ADDENDUM NO. 3

Center Grove High School Parking Lot and Canopy

Project No. 224140.00

Addendum No. 3, 1 item, 1 page
Revised Drawing Sheets: C0 COVER, TOPOGRAPHIC SURVEY 1-3

SHEET NO.:
2 OF 3

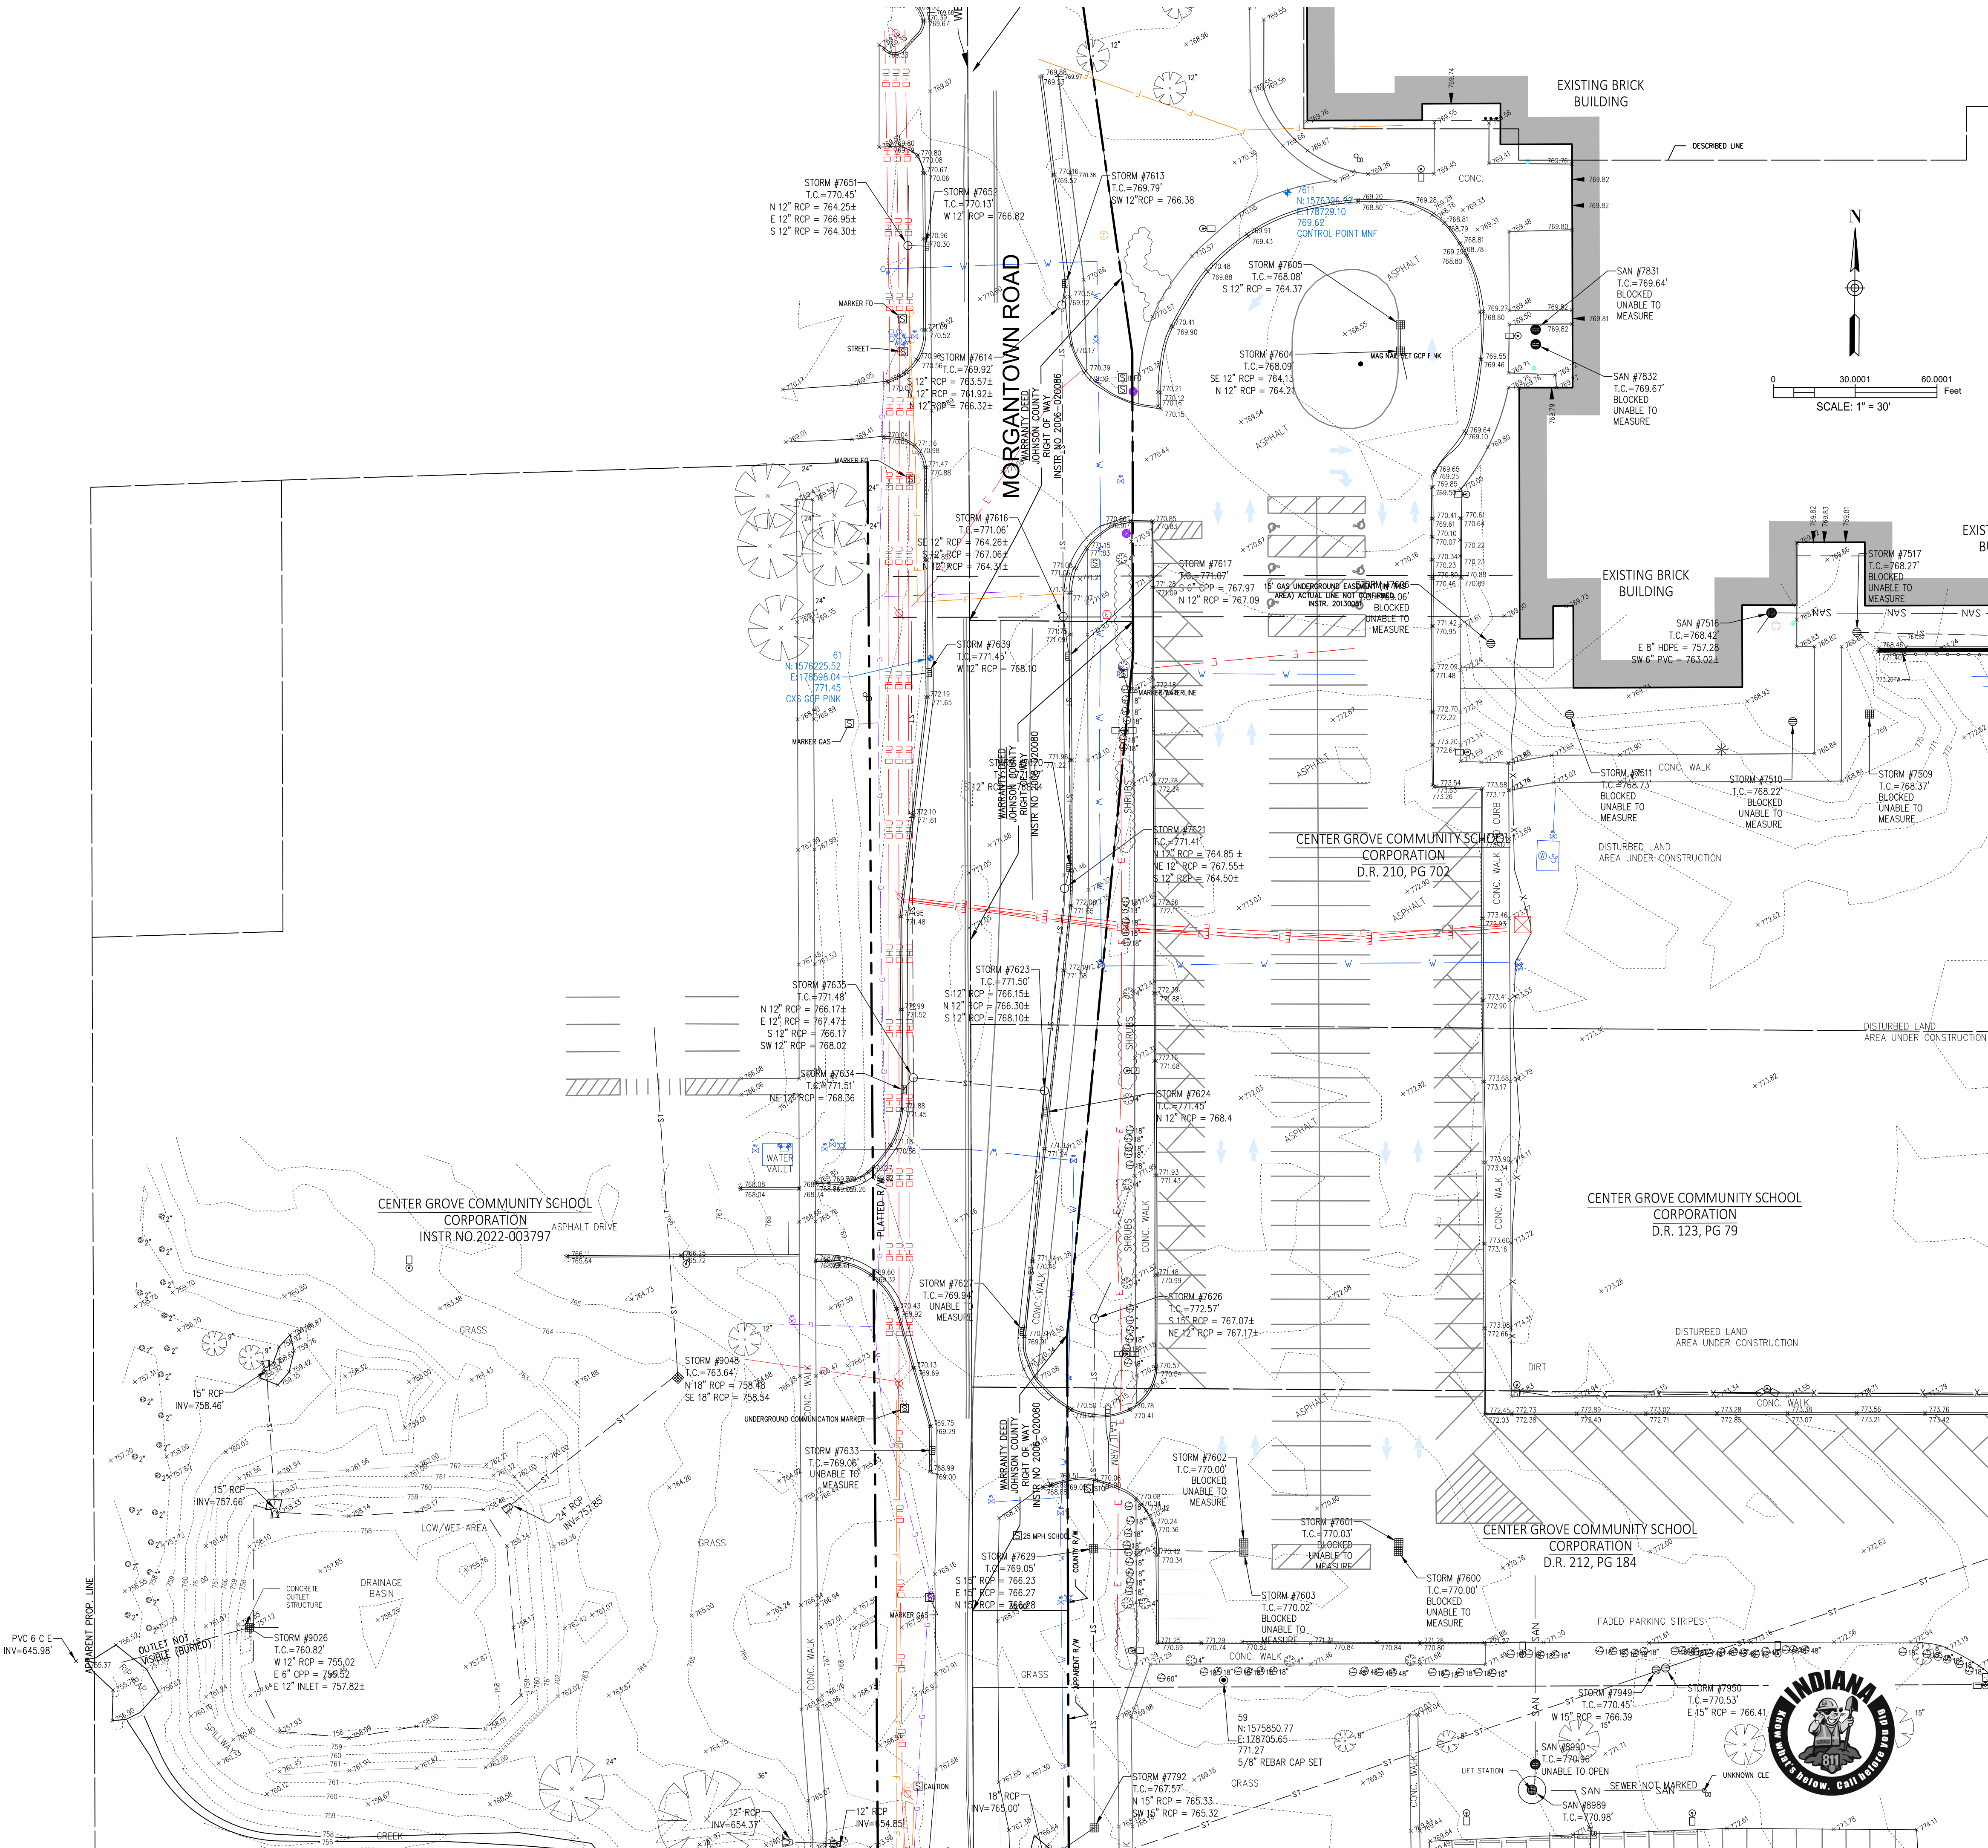
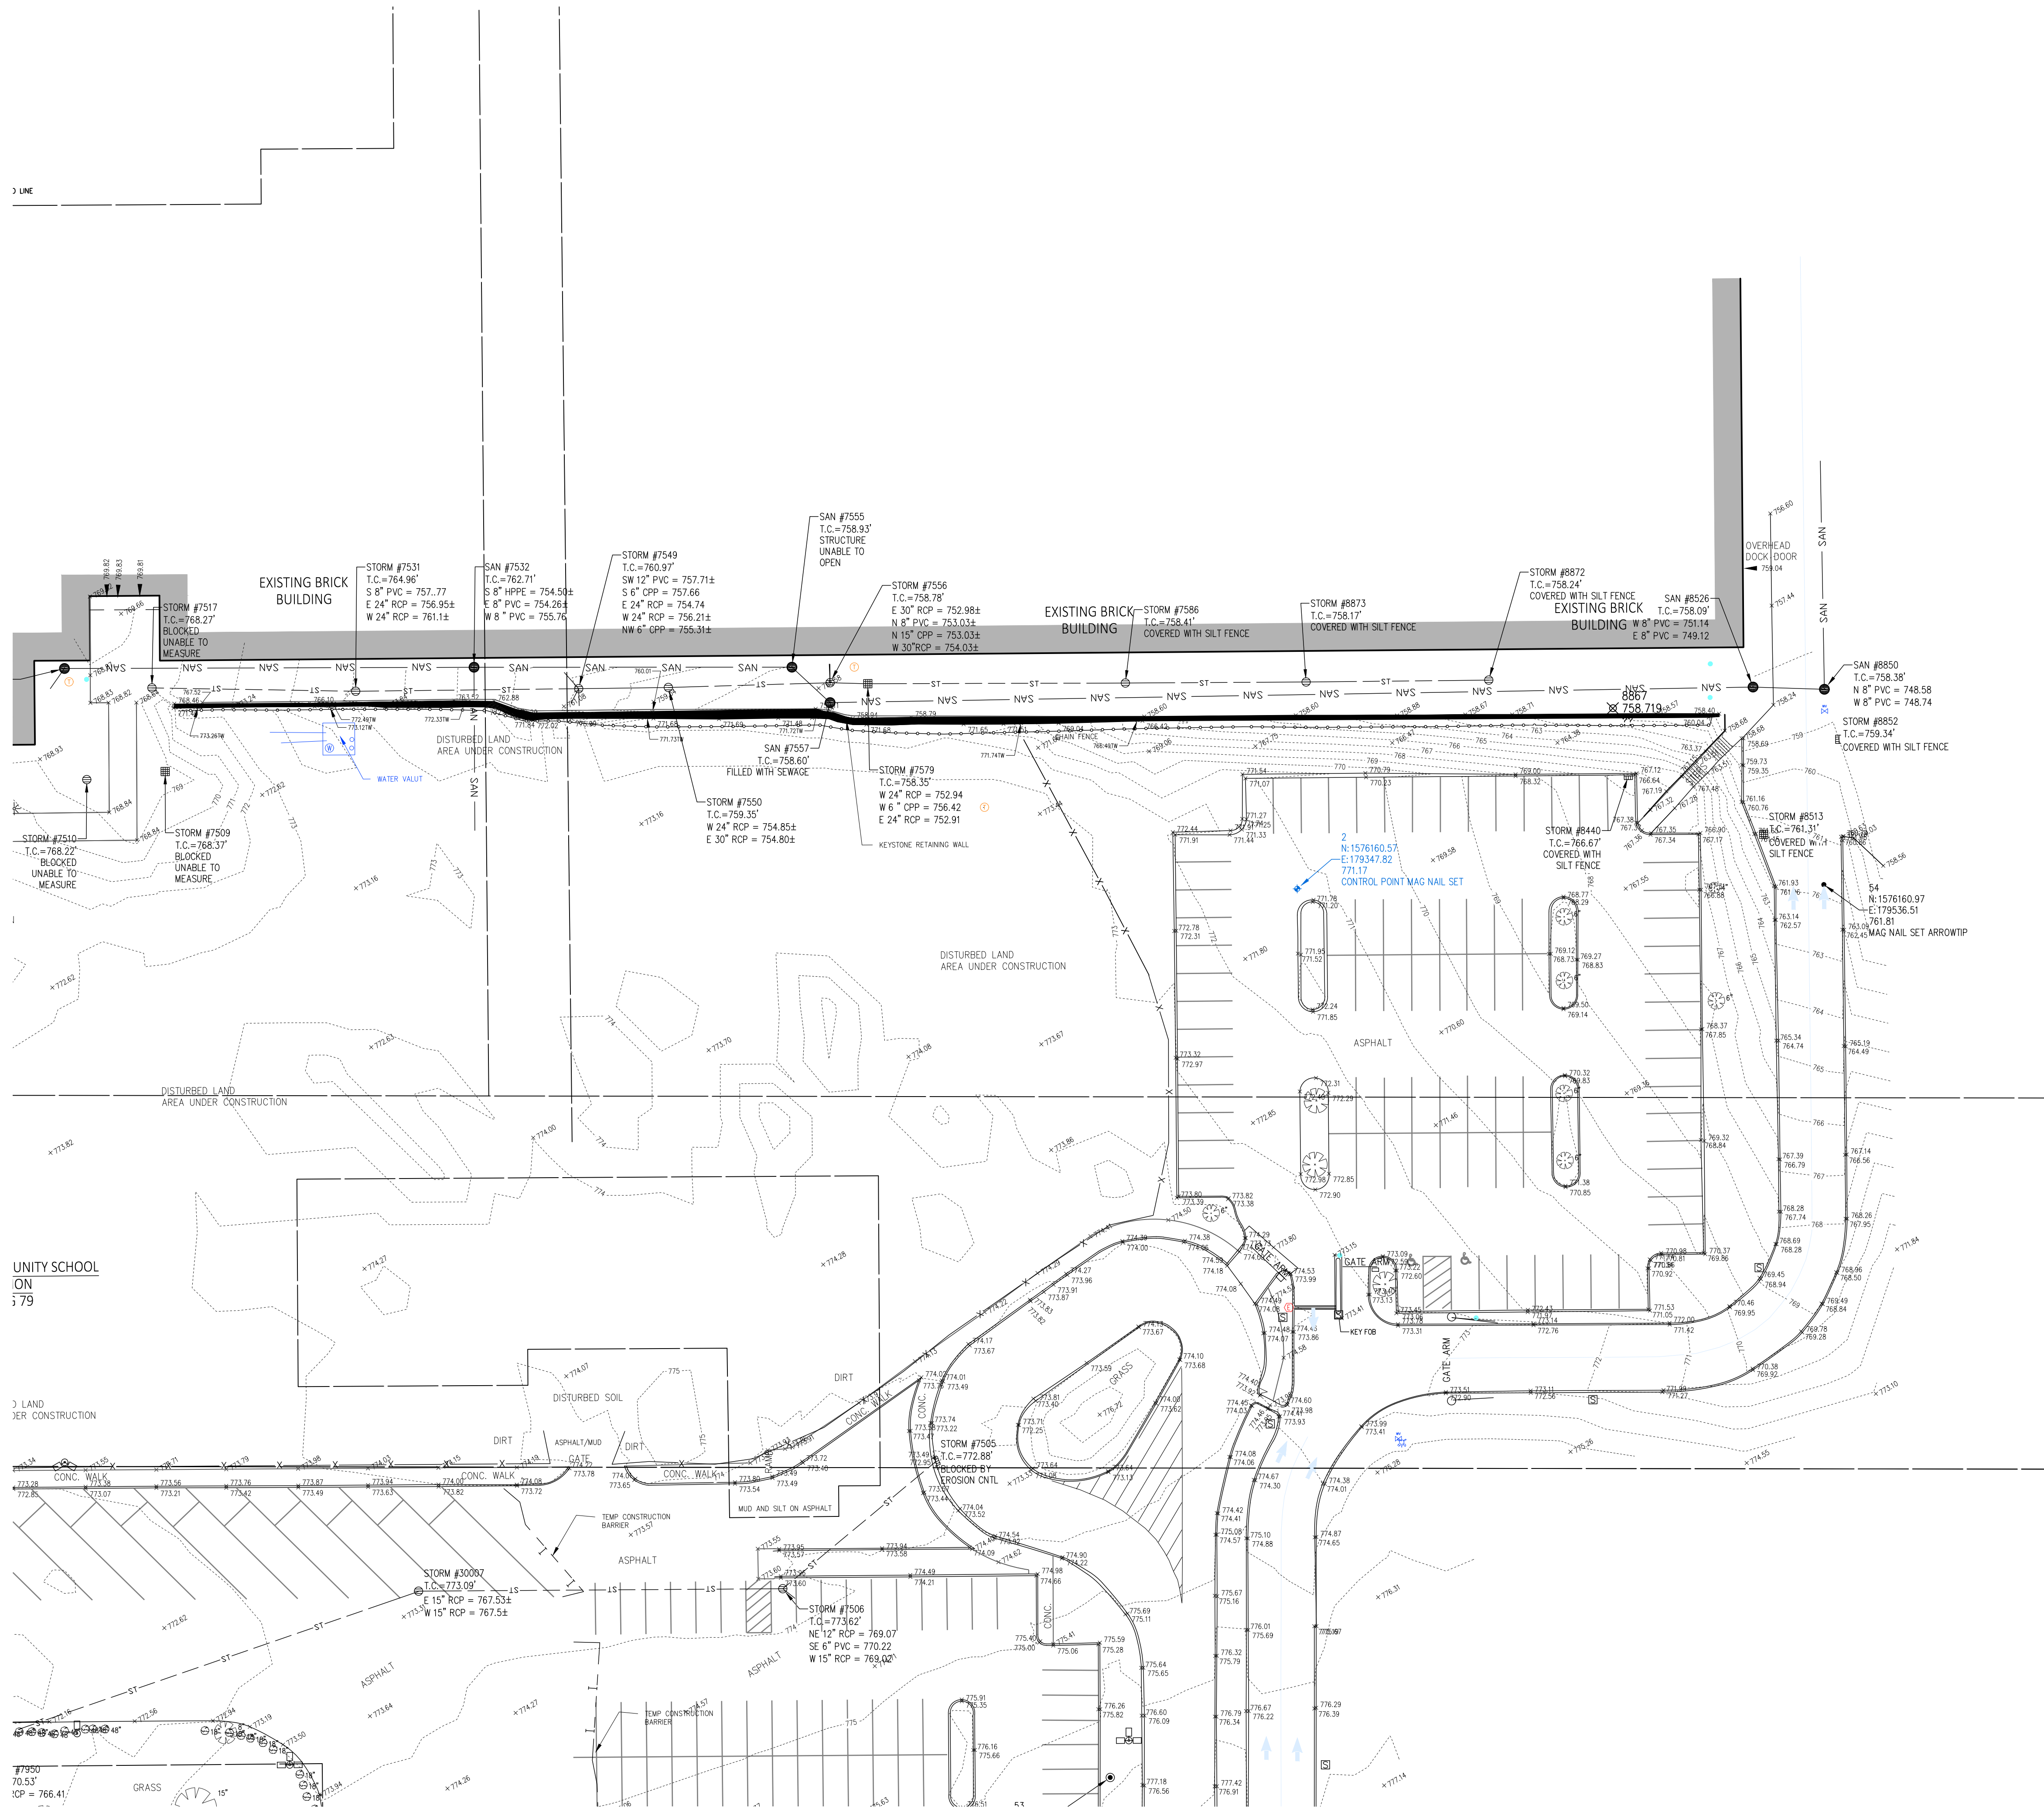
REVISIONS
1 05/01/2025 - ELEVATIONS DATUM TO GEOID FOR PTS #22160-22172
